Subject: AP1000 Response to Request for Additional Information (SRP 9)

ENCLOSURE 1

Response to Request for Additional Information on SRP Section 9

Figure 9.1-6 (Sheet 1 of 2)
Spent Fuel Pool Cooling System
Piping and Instrumentation Diagram
(REF) SFS 001

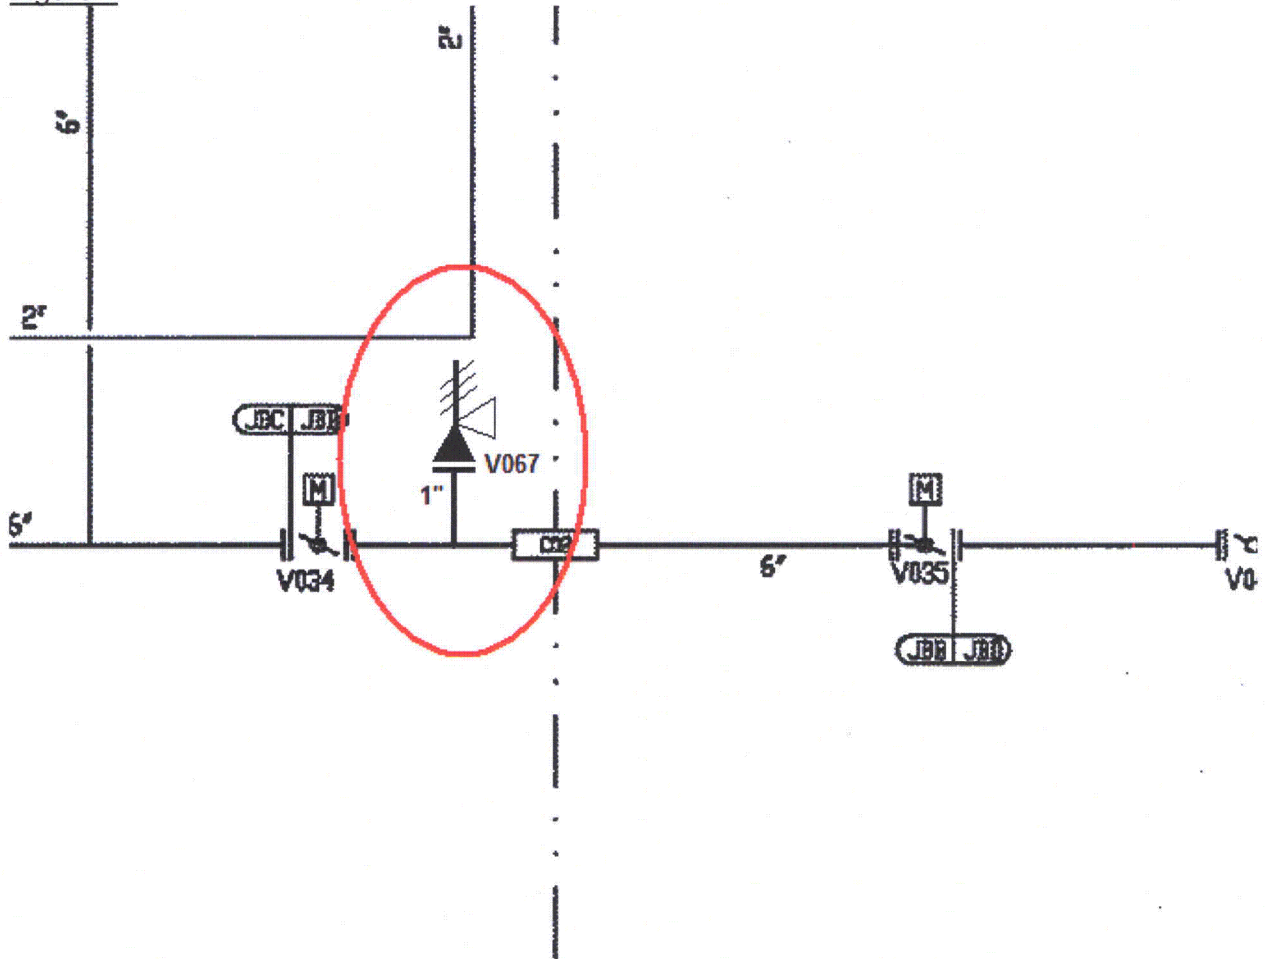
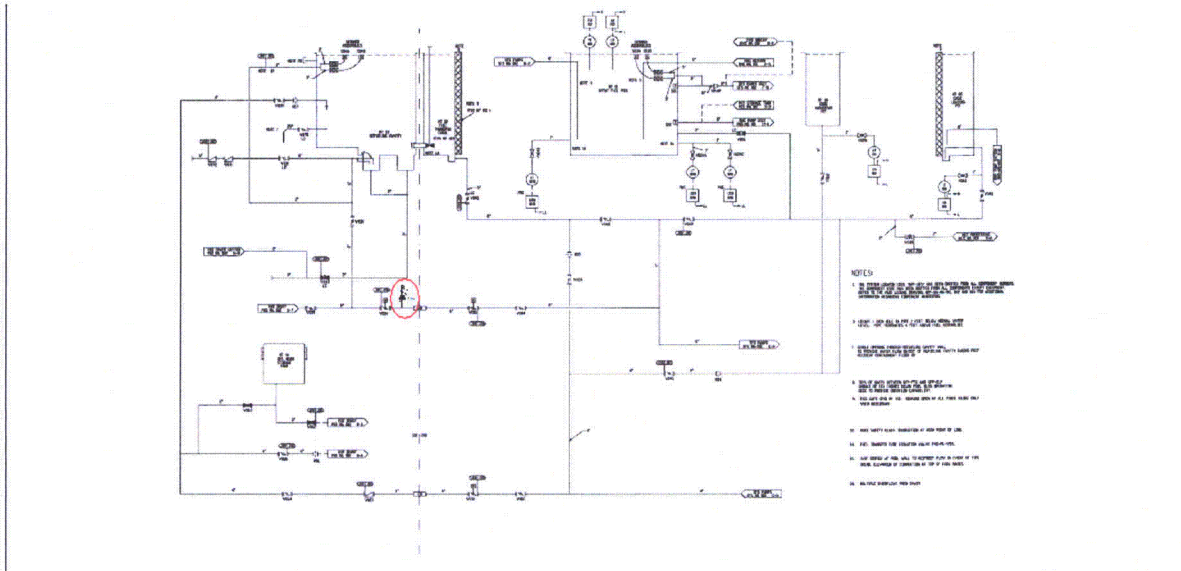
Table 6.2.3-1 "Containment Mechanical Penetrations and Isolation Valves" lists each containment penetration and provides a summary of the containment isolation characteristics. Table 6.2.3-1 Sheet 2 of 4 identifies the containment isolation valves related to the spent fuel pool. Valve SFS-PL-V067 is a pressure release valve located between SFS-PL-V034 and SFS-PL-V035. Tier 1 Table 2.2.1-1 also identifies the same pressure release valve. Figure 9.1-6 "Spent Fuel Pool Cooling System Piping and Instrumentation Diagram," Sheet 1 of 2 does not show valve SFS-PL-V067.

The staff requests that the applicant update Figure 9.1-6 Sheet 1 to include valve SFS-PL-V067.

Since Table 6.2.3-1 and Tier 1 Table 2.2.1-1 identify the valve, Figure 9.1-6 should also include the valve.

Figure 9.1-6 will include the following valve and attached line. The Figure 1 is enlarged and cropped from Figure 2, such that necessary details can adequately be viewed.
